METROPOLITAN GOVERNMENT OF NASHVILLE AND DAVIDSON COUNTY

STAFF RECOMMENDATION
239 Lauderdale Road
September 19, 2012

Application: Demolition; New construction – infill
District: Cherokee Park Neighborhood Conservation Zoning Overlay
Council District: 24
Map and Parcel Number: 10312008400
Applicant: Kevin Mitchel, Designer
Project Lead: Sean Alexander, sean.alexander@nashville.gov

239 Lauderdale Road, looking east. Note the difference in floor heights between subject property and adjacent building.

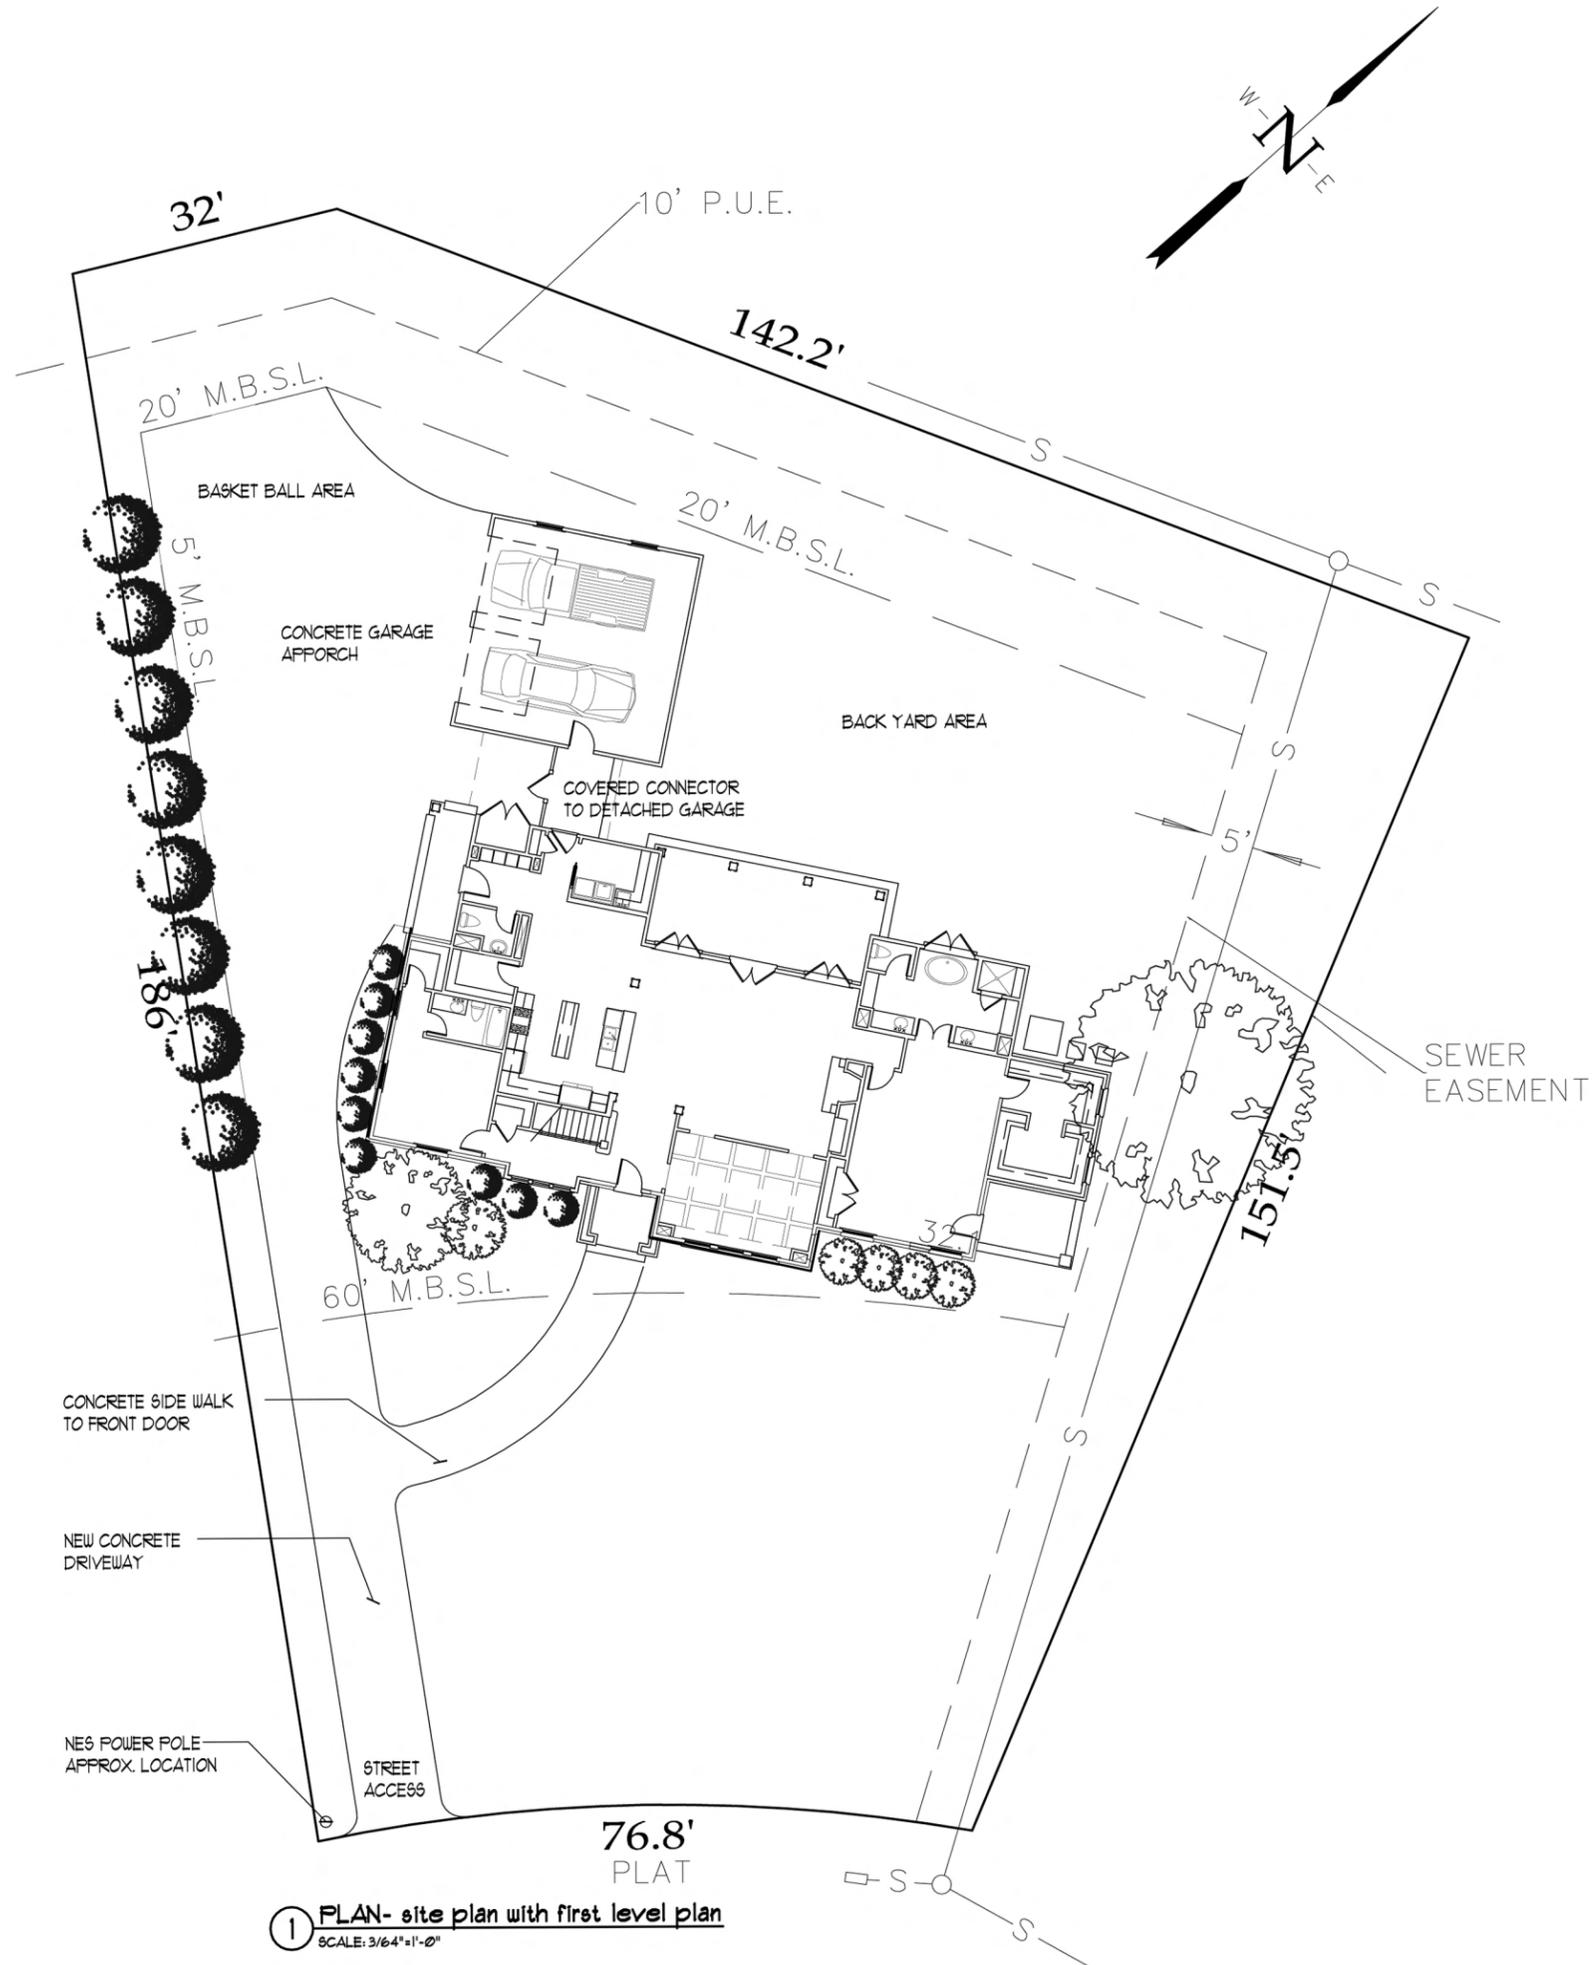
The new building will have two main components. The smaller of the two will be one and one-half stories tall and will cover roughly one-third of the footprint area of the non-contributing structure. This section of the house will have a side-facing gabled-roof with a ridge height of twenty-eight feet, six inches (28'-6") above grade. The eave height will be ten feet, six inches (10'-6") above grade, roughly the same height as the eaves of the non-contributing house. The larger component will be a full two-stories tall, with a maximum roof ridge height of thirty-four feet (34') above grade and a primary eave height of nineteen feet, six inches (19'-6"). Although this would be taller than many of the Tudor Revival style houses nearby, the eave and ridge heights are compatible with those of surrounding two-story Colonial Revival style houses. The height of this structure will be lessened to some extent because the grade at floor level is approximately three feet (3') below street level, and because of the unusually deep front setback. The foundation height will be minimal because the concrete slab is going to be re-used. For these reasons, staff finds that the heights of the new primary building meet guideline II.B.1.a.

1 ELEVATION - front/street
SCALE: 1/8"=1'-0"

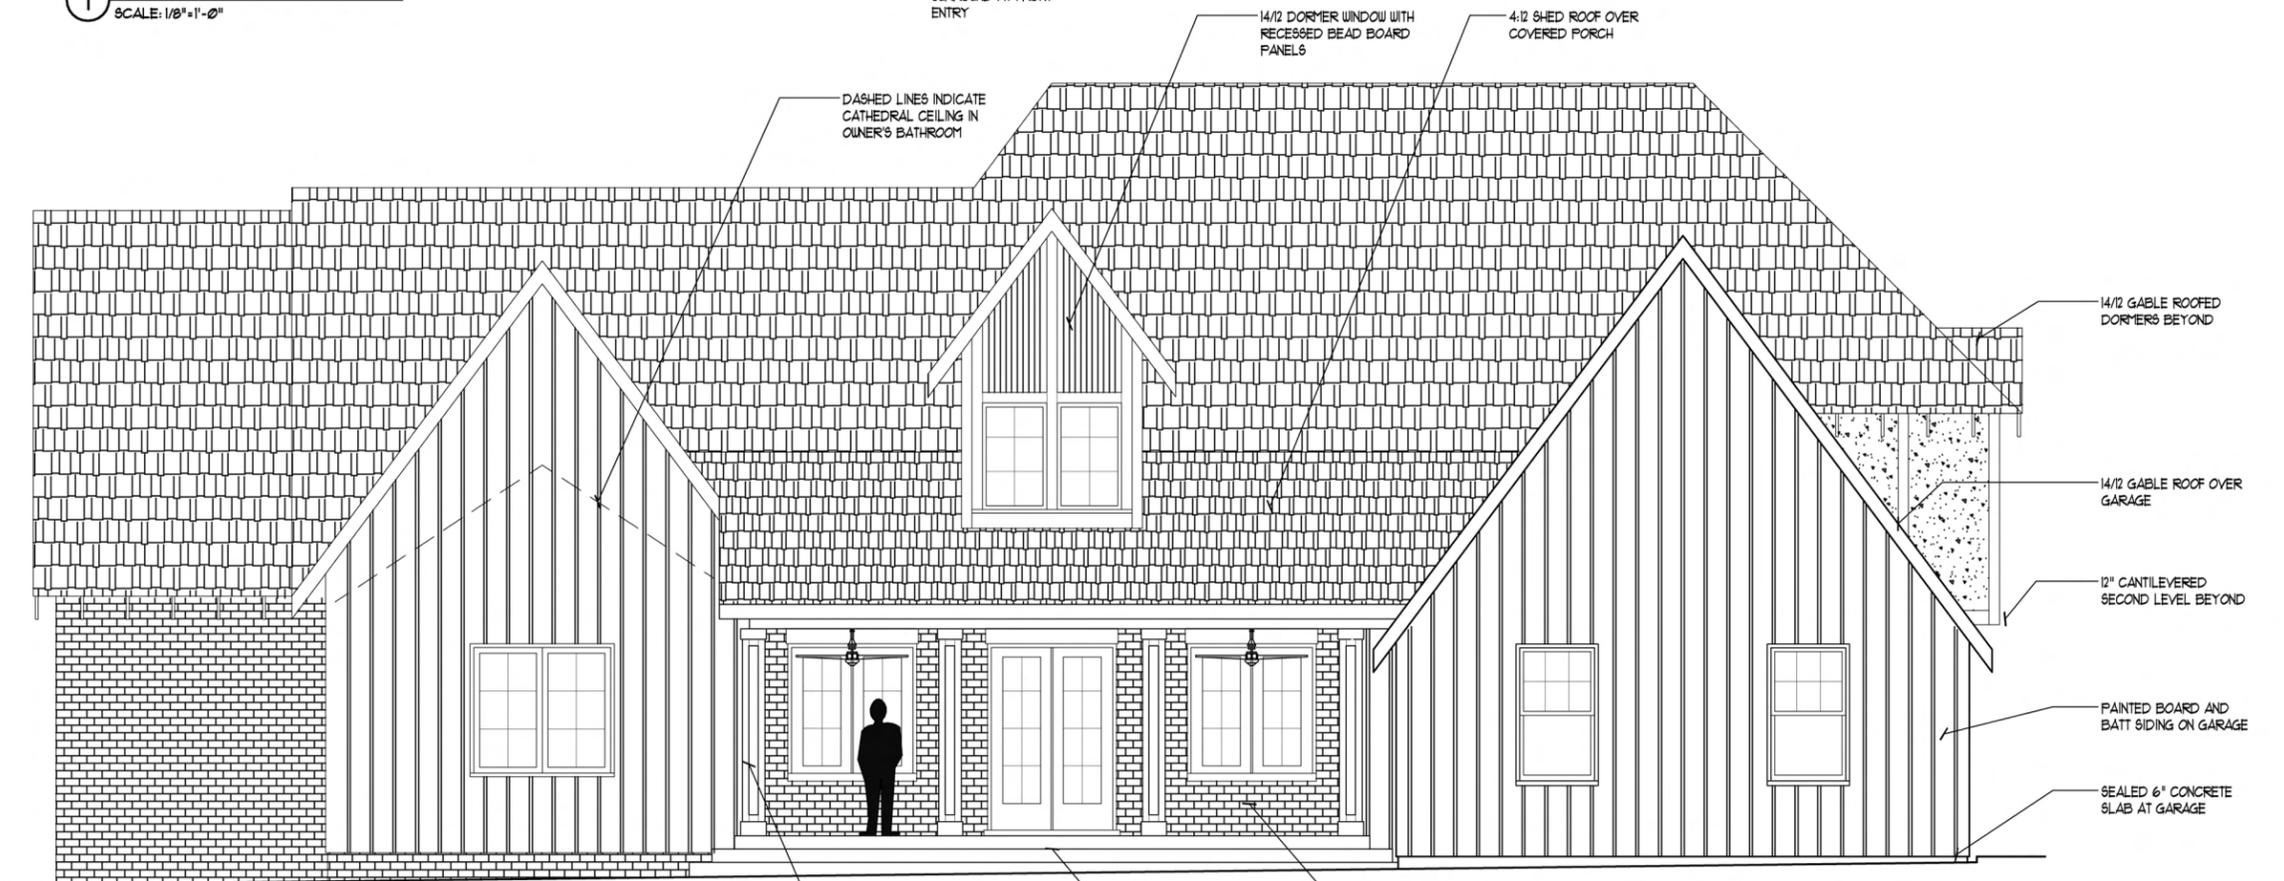
The primary roof of the larger component of the structure will be a side-oriented hip with a 12:12 pitch. The roofs of the shorter component, of a prominent front projecting bay, and of smaller dormers, will be 16:12 gables. The dormer at the right of the front elevation would be stacked above the first story wall below, which is not typical of dormers on historic houses nearby. With this dormer set back two feet (2') from the wall below, the roof forms would be compatible with those of surrounding historic houses nearby, and meet guideline II.B.1.e. Other small gables on the left side of the building, though not set back from the wall, are more akin to "eyebrow" dormers which are often not set back from walls.

1. Staff approve a sample of the brick, masonry stain, windows and doors, and roof color;
2. The dormer on the right side of the front elevation shall set back two feet (2’) from the wall below;

1. Staff approve a sample of the brick, masonry stain, windows and doors, and roof color;
2. The dormer on the right side of the front elevation shall set back two feet (2’) from the wall below;
